Independent Review of Flood Modelling Undertaken for the Macintyre River Floodplain

Inland Rail Project - Border to Gowrie (B2G)

Goondiwindi Regional Council
1283-02-E, 29 April 2021

Figure 7-2 - Differences in modelled peak flood levels between the 1976 event and the 1% AEP design event

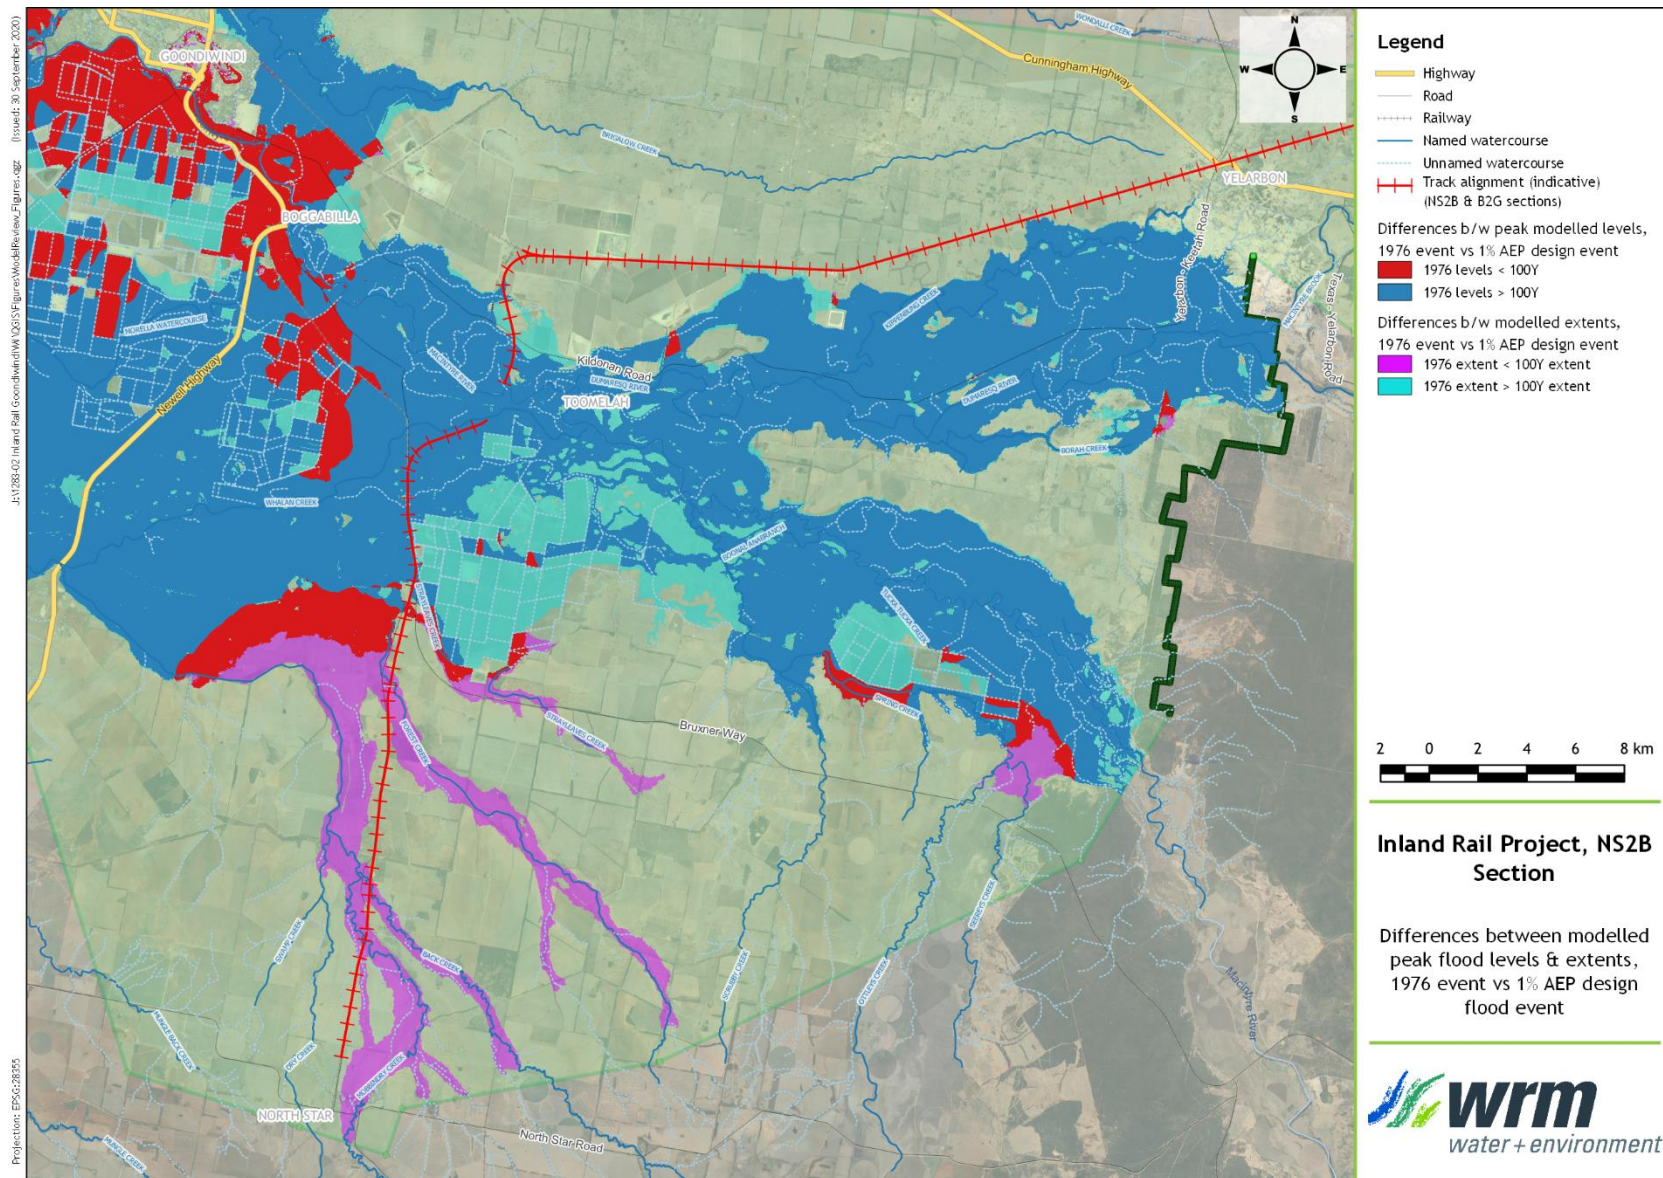
- The 1976 peak flood levels are expected to be higher than the 1% AEP peak flood levels because the 1976 event has been determined to be between a 1 in 200 and 1 in 500 AEP event. However, for the Macintyre River reach between Boggabilla and Goondiwindi, parts of the floodplain between the Newell Highway and the proposed rail corridor and the Ottleys Creek floodplain, the modelled 1% AEP peak flood levels are higher than the 1976 peak flood levels (see Figure 7-2). The reasons for this apparent inconsistency are not explained.

Figure 7-3 - Differences in modelled peak flood levels between the 1996 event and the 1% AEP design event

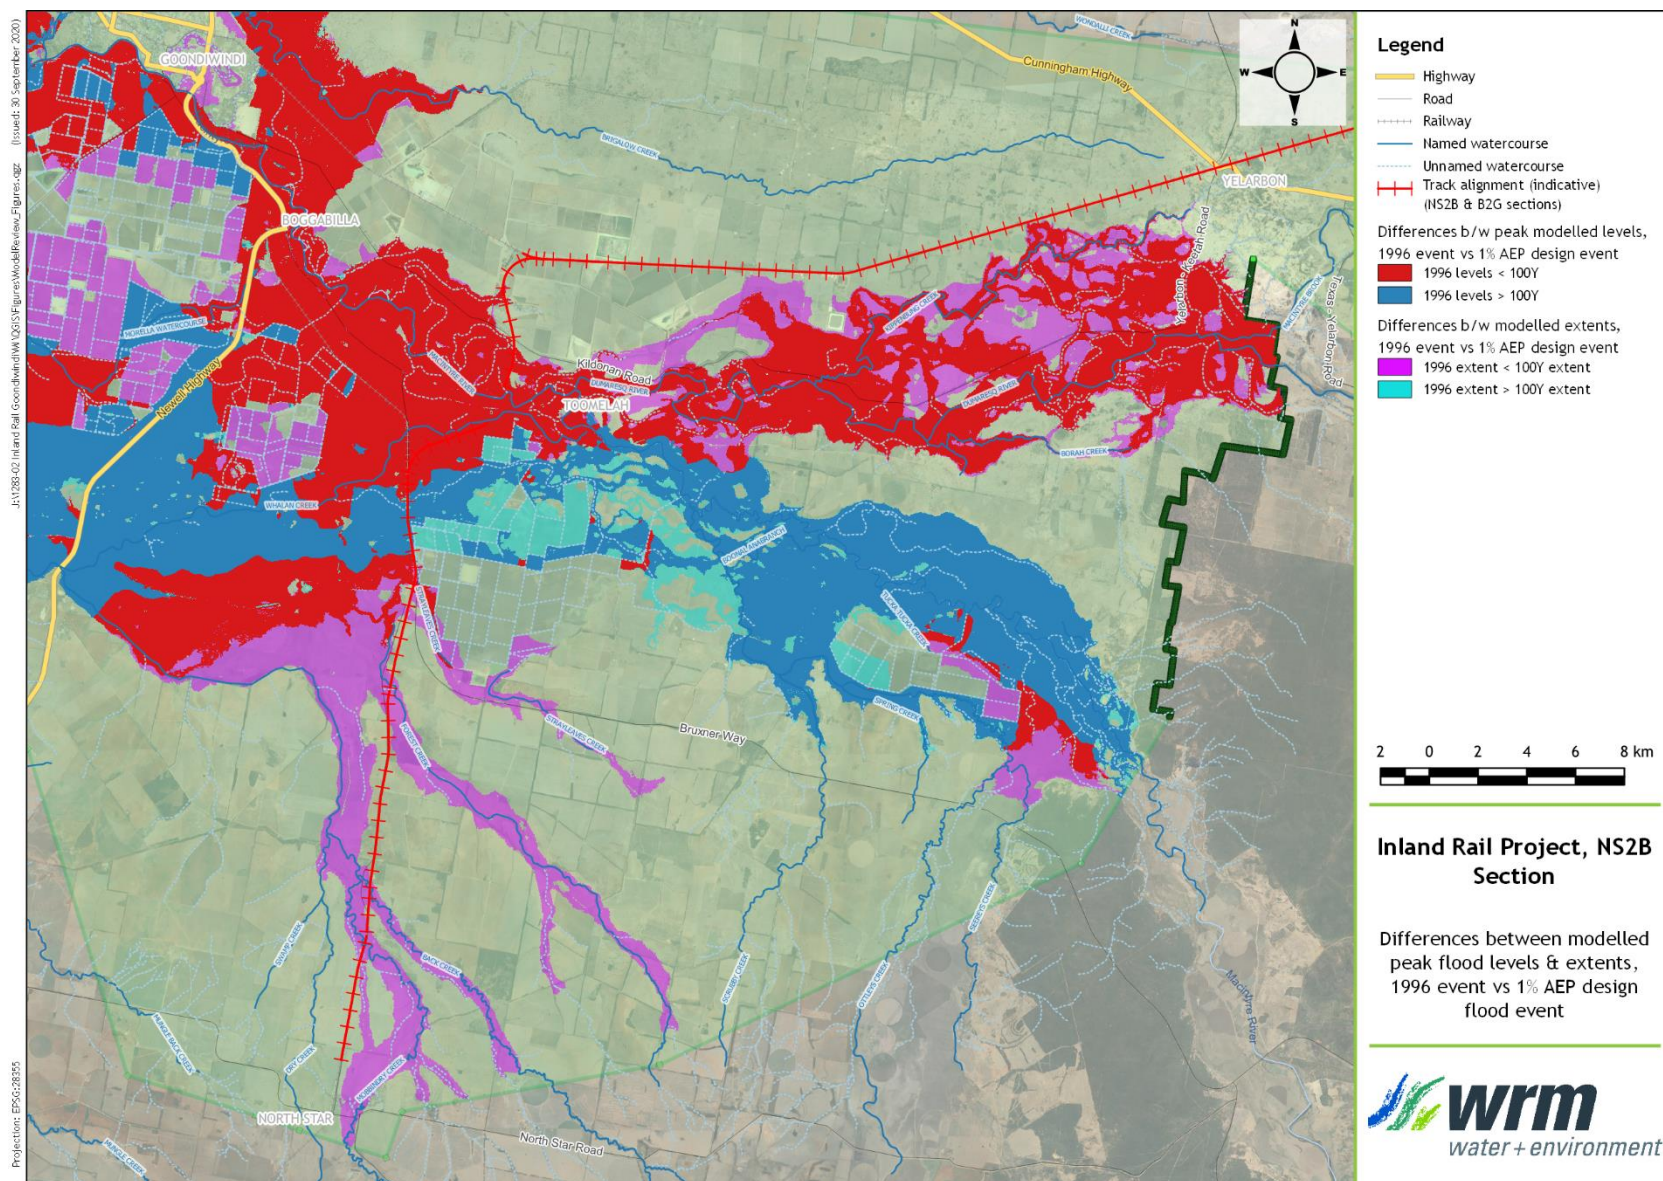
- The 1996 peak flood levels are expected to be lower than the 1% AEP peak flood levels because the 1996 event has been determined to be between a 1 in 30 and 1 in 50 AEP event. However, for the Macintyre River upstream of its confluence with the Dumaresq River including Ottleys and Scrubby creeks, and a significant part of the Whalan Creek floodplain, the modelled 1% AEP peak flood levels are lower than the 1996 peak flood levels (see Figure 7-3). The reasons for this apparent inconsistency are not explained. Again, the impact on modelled flood levels along the minor
